Access Compliance Report

Public Rights-of-Way (Curb Ramps)

Intersection ID: 10041074	Main Street: WATER RIDGE PY	Cross Street: N/A	Location: SW
ADA ID: 8C6A96D1439D	Ramp Type: PerpDiag	Initial Pass/Fail: Fail	Overall Compliance: No Severity Score: 46.25

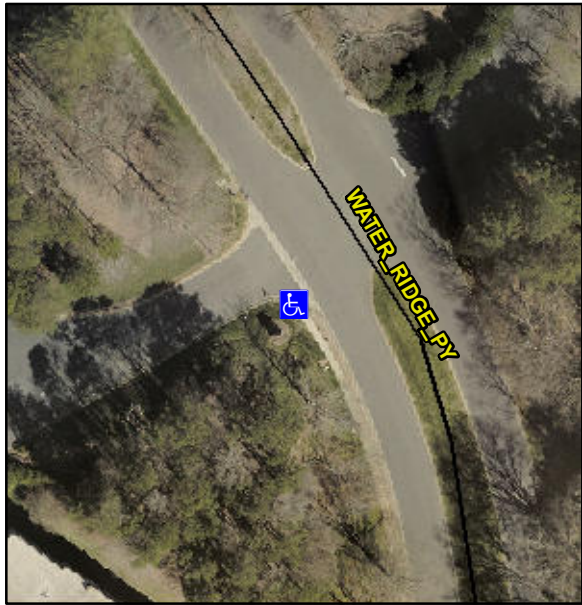
Codes/Mitigation Info/Possible Solution		Field Measurements/Component Compliance					
	Possible Solutions:						
	Remove & Replace Curb Ramp With Two New Directional Ramps or Equivalent.	N/A	Ramp Length (in)	39.0	No	Ramp Slope (%)	10.4
		No	Ramp Width (in)	38.0	No	Ramp XSlope (%)	8.4
		N/A	Flare Type LT	N/A	N/A	Flare Type RT	N/A
		N/A	Flare Slope LT (%)	N/A	N/A	Flare Slope RT (%)	N/A
		N/A	Flare Traversable LT?	N/A	N/A	Flare Traversable RT?	N/A
		N/A	Landing Length (in)	N/A	N/A	DWS Provided?	N/A
		N/A	Landing Width (in)	N/A	N/A	DWS Contrast?	N/A
		N/A	Landing Slope (%)	N/A	N/A	DWS Length (in)	N/A
		N/A	Landing X Slope (%)	N/A	N/A	DWS Full Width?	N/A
Surveyor Notes:	N/A	N/A	Landing Curb? (Y/N)	N/A	N/A	DWS Offset (in)	N/A
		N/A	Shared Landing?	N/A			
		N/A	Gutter Ponding?	N/A	N/A	Gutter Slope (%)	N/A
		N/A	Gutter Lip Ht (in)	N/A	N/A	Gutter X Slope (%)	N/A
		N/A	Painted X Walk1?	No	N/A	Painted X Walk2?	No
			X Walk 1 Direction	To E		X Walk 2 Direction	To N

N/A	X Walk 1 Width (in)	N/A	N/A	X Walk 2 Width (in)	N/A
			X Walk 1 Slope (%)	2.7		X Walk 2 Slope (%)	8.4
			X Walk 1 X Slope (%)	4.0		X Walk 2 X Slope (%)	4.8
		N/A	Ramp inside XWalk1?	N/A	N/A	Ramp inside XWalk2?	N/A
PROW/ADA:	Not Found, R304.5.1, R304.2.2, R304.5.3		Road Slope (%)	6.2	N/A	Clear Space?	N/A
			Road X Slope (%)	2.1	N/A	Clear Space to XWalk (in)	N/A
		N/A	Any Obstructions?	N/A	N/A	Storm Grate/Utility Hazard?	N/A
			Obstruction Type			Storm Grate/Utility Type	
					N/A		N/A
					Yes	Surface Condition? (G/P)	Good
	Total Cost:		\$	3200.00			
	Street 1 Name		WATER RIDGE PY				
	Stop Condition-Street 2		None				
	Street 2 Name		ENTRANCE				
Stop Condition-Street 1		StopSign
